Consists of responses to Outstanding items of NRC report to ACRS dtd 11/04/77 in the matter of the Donald C. Cook Nuclear Plant Unit #2...w/att supporting information.....

NS-PLC-4546
S.O. AMP-460Mr. Edson G. Case, Acting Director
Office of Nuclear Reactor Regulation
U. S. Nuclear Regulatory Commission
7920 Norfolk Avenue
Bethesda, Maryland 20014

AMERICAN ELECTRIC POWER
Donald C. Cook Nuclear Plant Unit 2
Responses to Outstanding Items of NRC Report to ACRS

FIGURE 2 (B) (2)

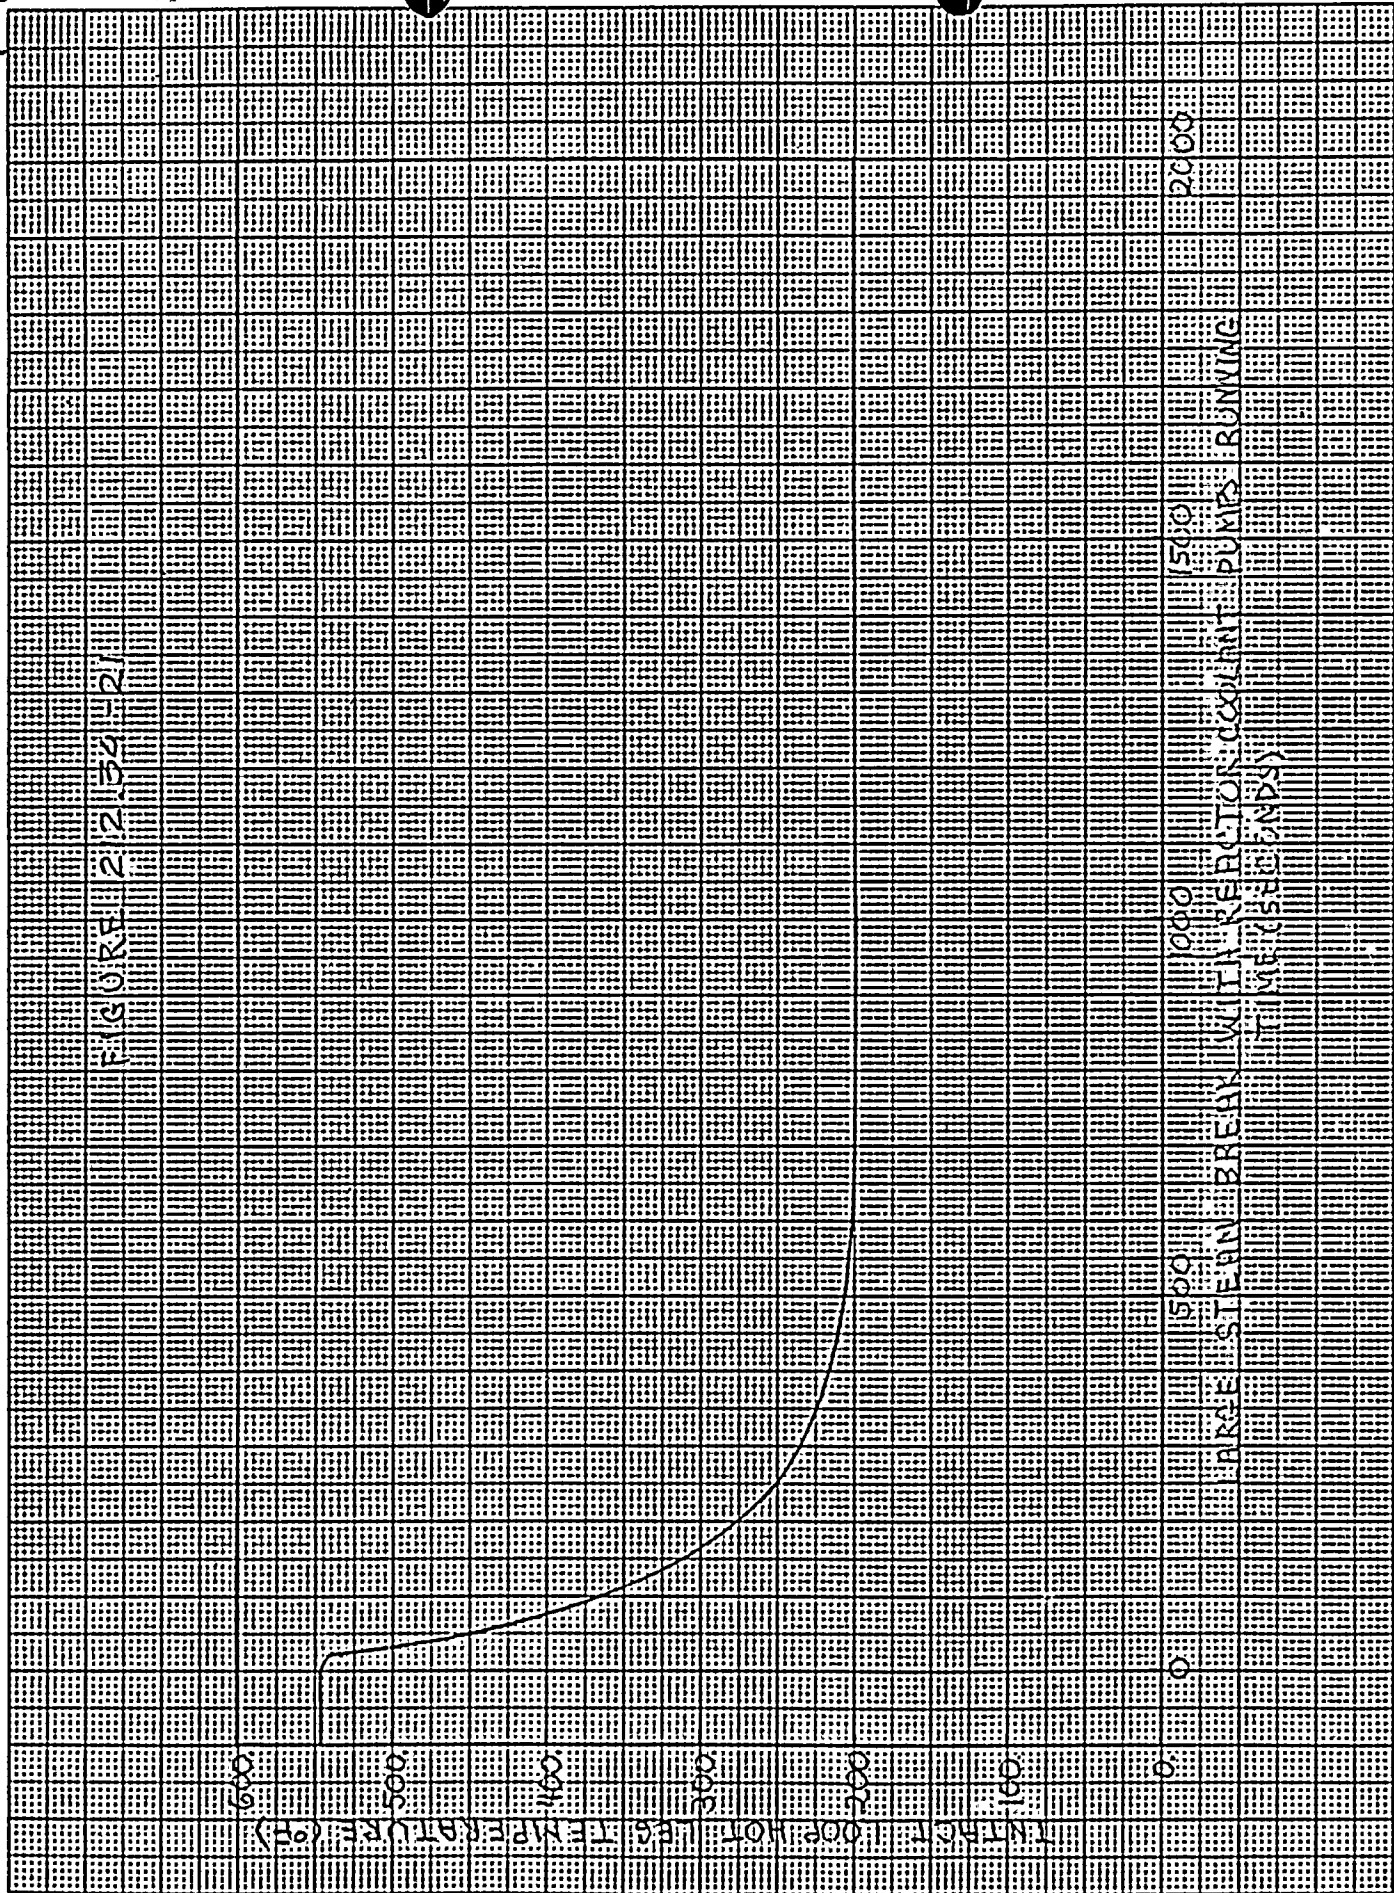
Figure 212.34-21 presents the hot leg temperature in the intact loops of the reactor coolant system for a hypothetical large steam line break transient. At 200 seconds (the beginning of pressurizer refill) the hot leg temperature is approximately 280°F. This serves as the basis for the pressurizer fluid enthalpy of 250 Btu/lbm used in a conservative calculation of the pressurizer thick metal heat effect on coolant system repressurization following 9 steam line break.

Figure 212.34-21 corresponds to the case with full forced convection reactor coolant flow, presented in figures 212.34-1 - 212.34-4 (Amendment 78). A similar figure is not provided for the case with free convection reactor coolant flow. The evaluation of reactor vessel integrity performed for the response to question 212.34 indicated that a similar size initial flow depth of less than approximately 1/3 wall thickness would assure reactor vessel integrity for the design life of the plant. The additional pressure due to fluid flashing in the pressurizer is much greater for the case with forced convection in the reactor coolant
